Subject: Description of Permissive Change

FCC ID: 2AJ3WEBEQPW92

Model Name: EBE-QPW92

PCB board of EBE-QPW92-B (CIIPC)

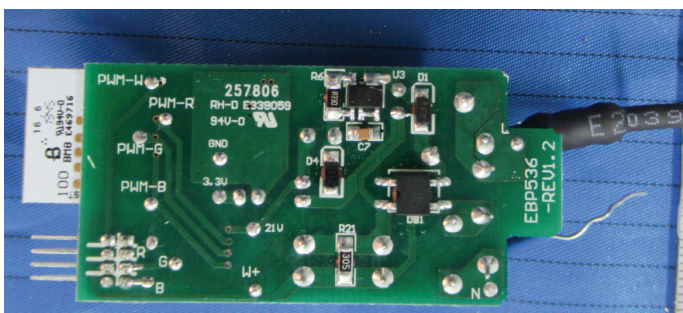
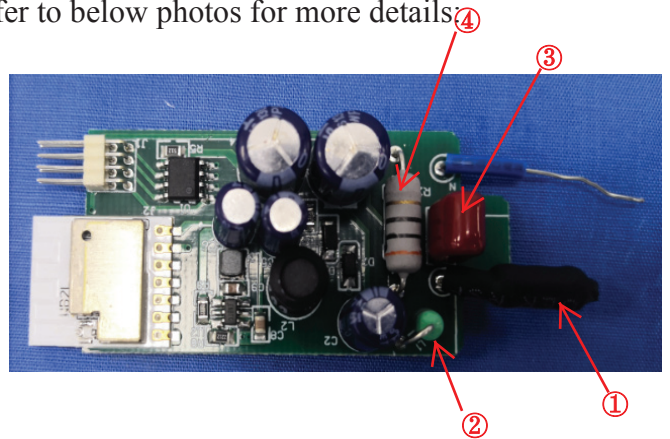
1. Add models: EBE-QPW92-B, BW904, BW914, BW924, BW944, BW210, BW010, BW310, BW410. And EBE-QPW92-B has been tested by BACL.
2. Comparing with the original tested model EBE-QPW92, the current tested model EBE-QPW92-B changed some components of PCB board. Please refer to below photos for more details:

- ①: The diameter of L wire was changed from 0.72mm to 0.55mm.
- ②: The 5*12 1mH color code inductance was changed to 4*10 2.2mH color code inductance.
- ③: 250V/220N was changed to 250V/100N
- ④: R22 safety resistance was changed from vertical type to horizontal type.
- ⑤: Changed the position of Diode D1.
- ⑥: Added the diode D5.
- ⑦、⑧: The postions of these two chip resistors are shifted from the top layer to the bottom layer.
